Response to Bournemouth Airport

Aircraft noise over Brockenhurst and compliance with AD 2.21

From the Brockenhurst Community Action Group. Prepared from the aircraft's own broadcast GPS data (ADS-B), 2023 to 2025, via the public OPDI and OpenSky datasets. Every figure is independently reproducible. All counts are minimums.

Bournemouth arrivals over Brockenhurst: breaches the radar-vectoring defence does not explain

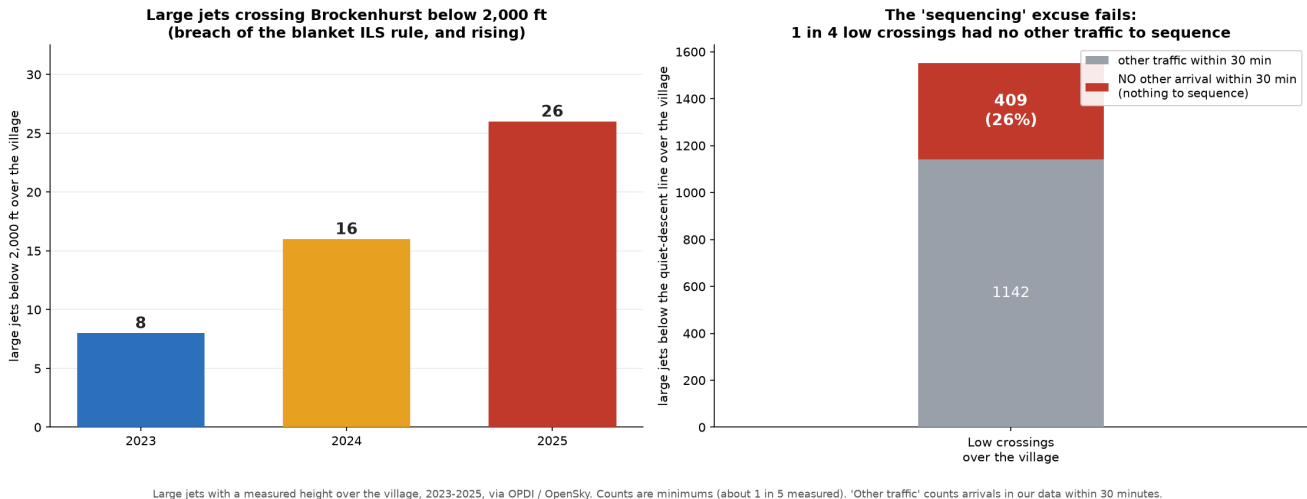
- Of the large jets crossing the village **below the continuous-descent height, 26% (409 flights) had no other arrival within 30 minutes**, and 45% had none within 15 minutes.
- **117 low night crossings had no other arrival within 30 minutes.**

Examples, which we invite you to check against your own records:

- **RYR5AM, 9 November 2025, 22:27, about 1,600 ft** over the village, no other arrival within 30 minutes.

- **EXS3618 (Jet2), 12 May 2025, 00:19, about 1,600 ft**, no other arrival within 30 minutes.
- **LAV932P (AlbaStar), 9 August 2025, 21:56, about 1,675 ft**, no other arrival within 30 minutes.

A single aircraft brought to 1,600 ft over a National Park village at night, with no other traffic in the sky, cannot be explained as the orderly management of traffic.
